Tender Ref No: JTC22T0033

CORRIGENDUM NO. 3

JTC INNOVATION CHALLENGE 2022

Challenge Statement 3: Real time automated optimisation of air-conditioning system

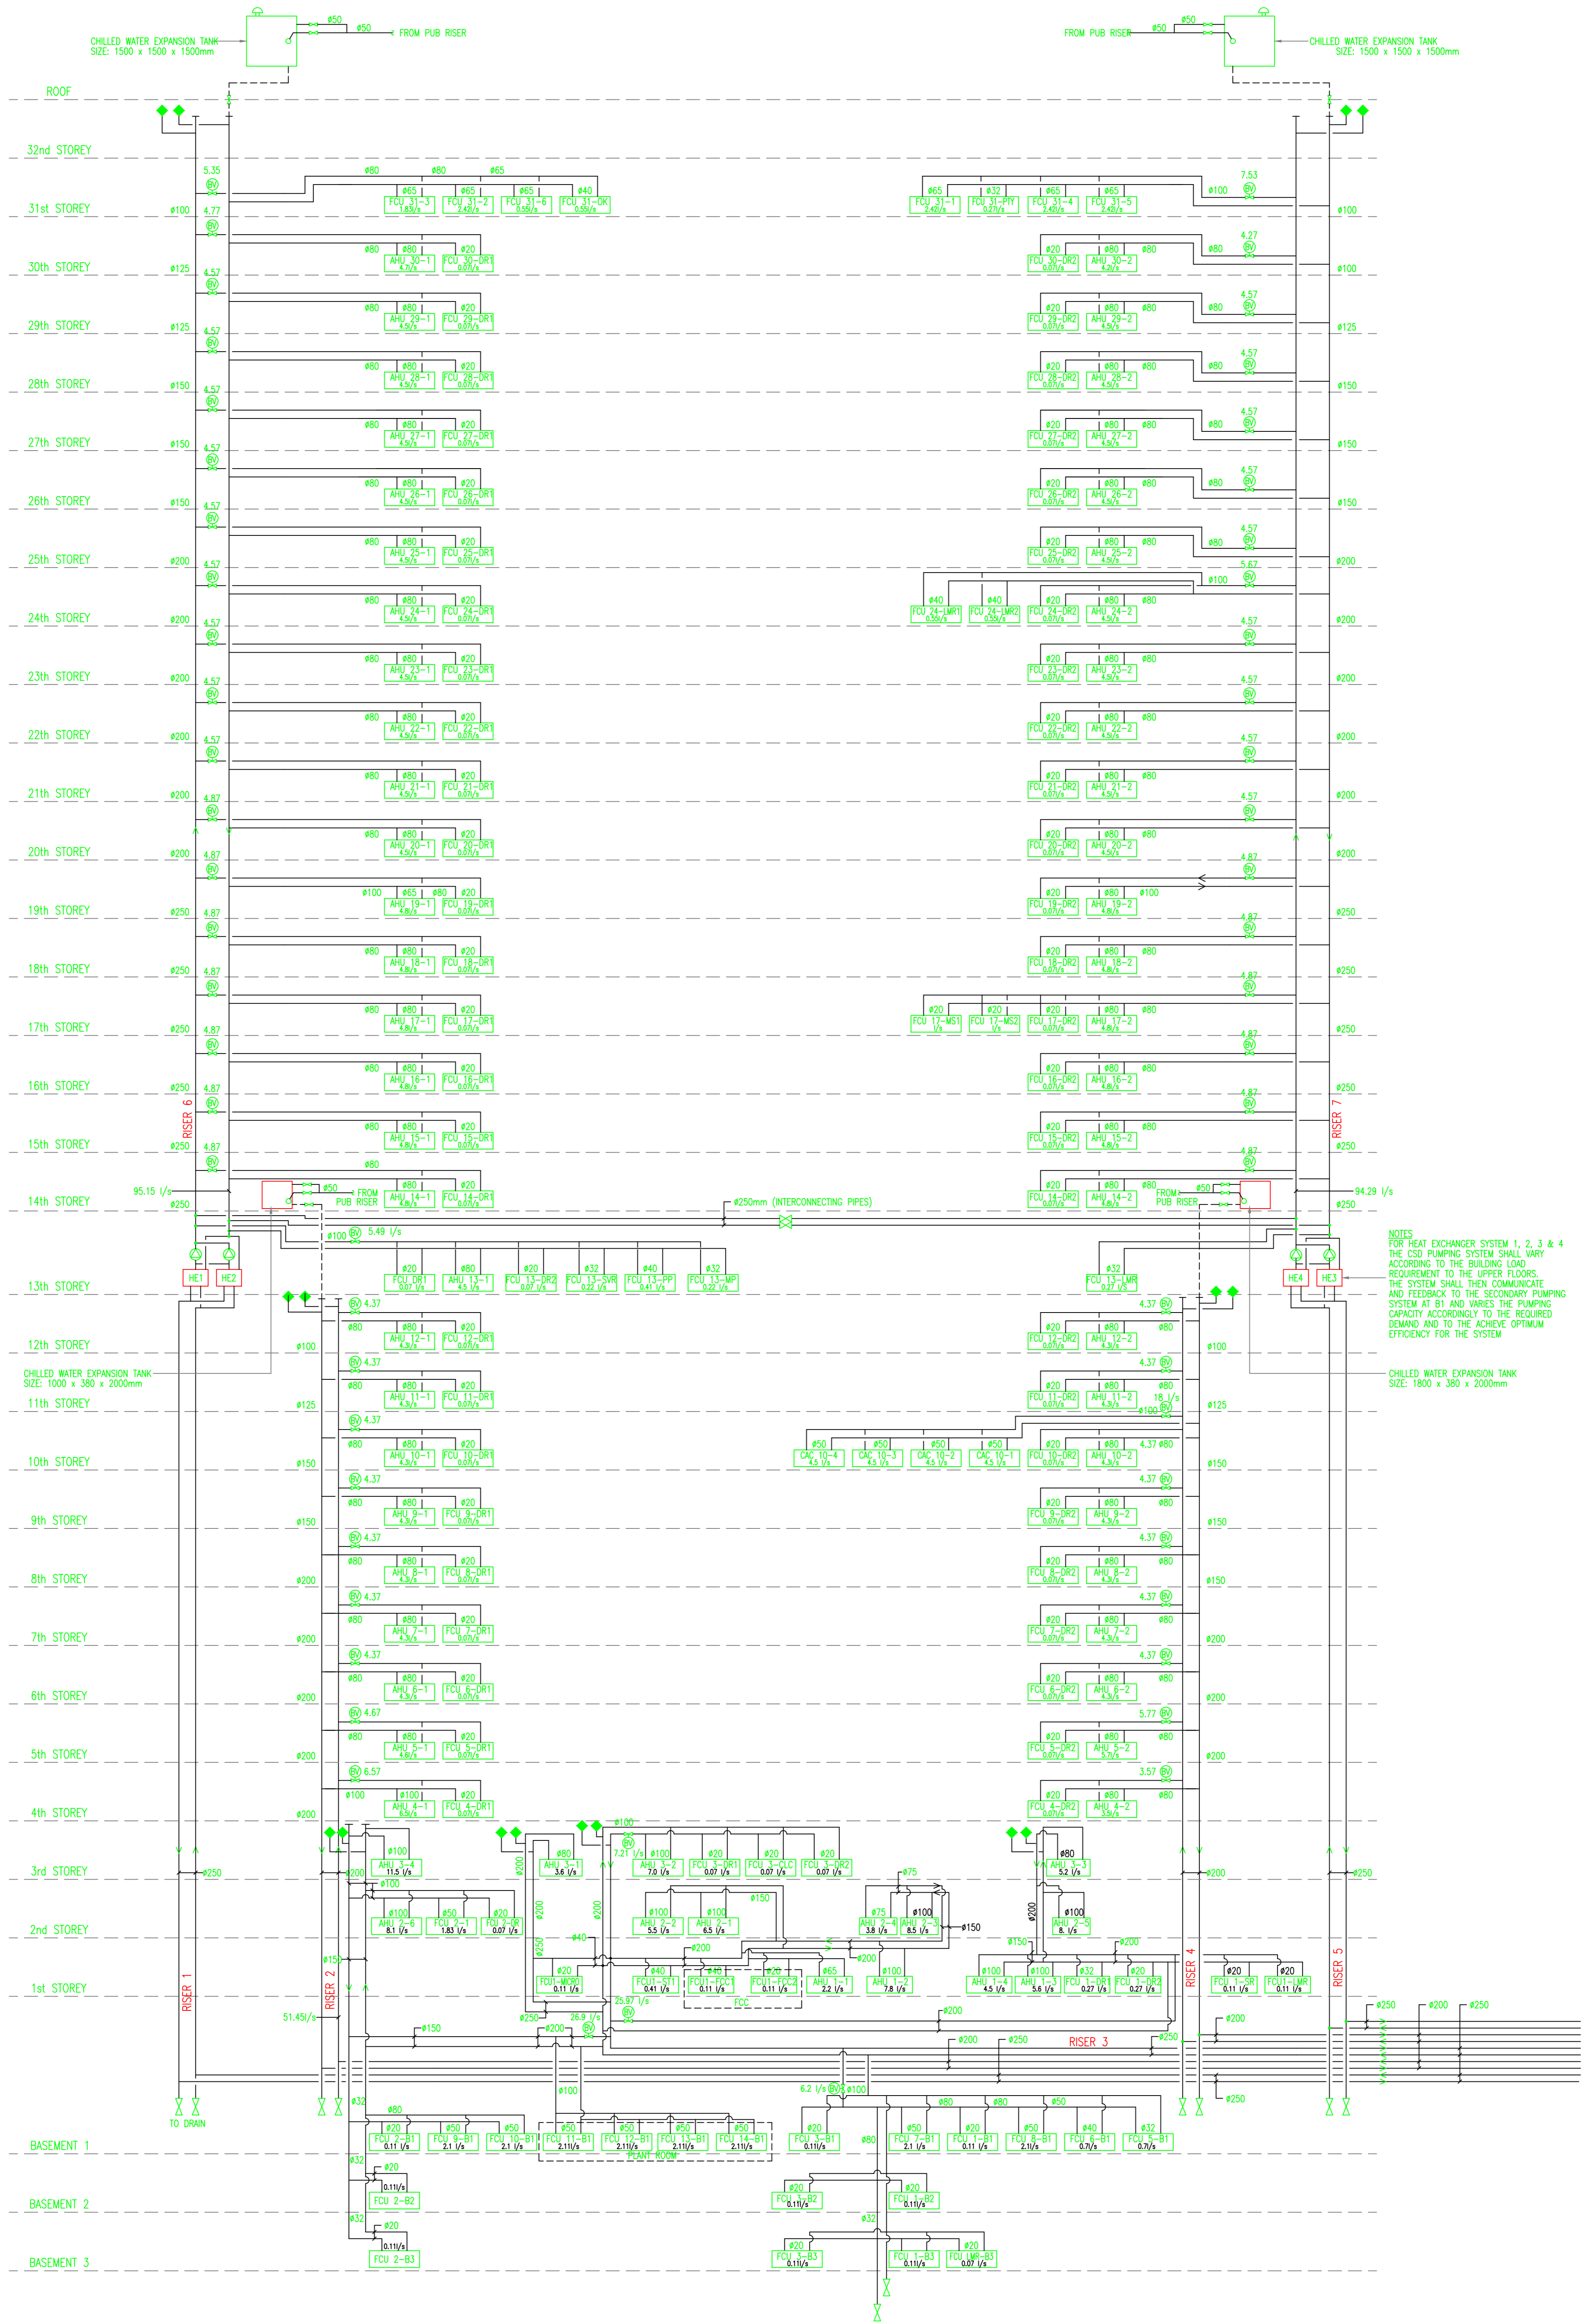
S/N	Query	Response
Challenge statement: Real time automated optimisation of air-conditioning system		
1	Can we request for overall system diagram consisting of Chiller, AHU, Pumps, Fan, regulation valves/dampers etc.	The airside schematic diagram and ACMV layout plans will be provided to successful applicant, if requested.
2	Can we request for the air build BMS system graphic and shop drawings for the test area, like Chiller plant, AHUs, VAVs?	Please see Annex A for chilled water system schematic.
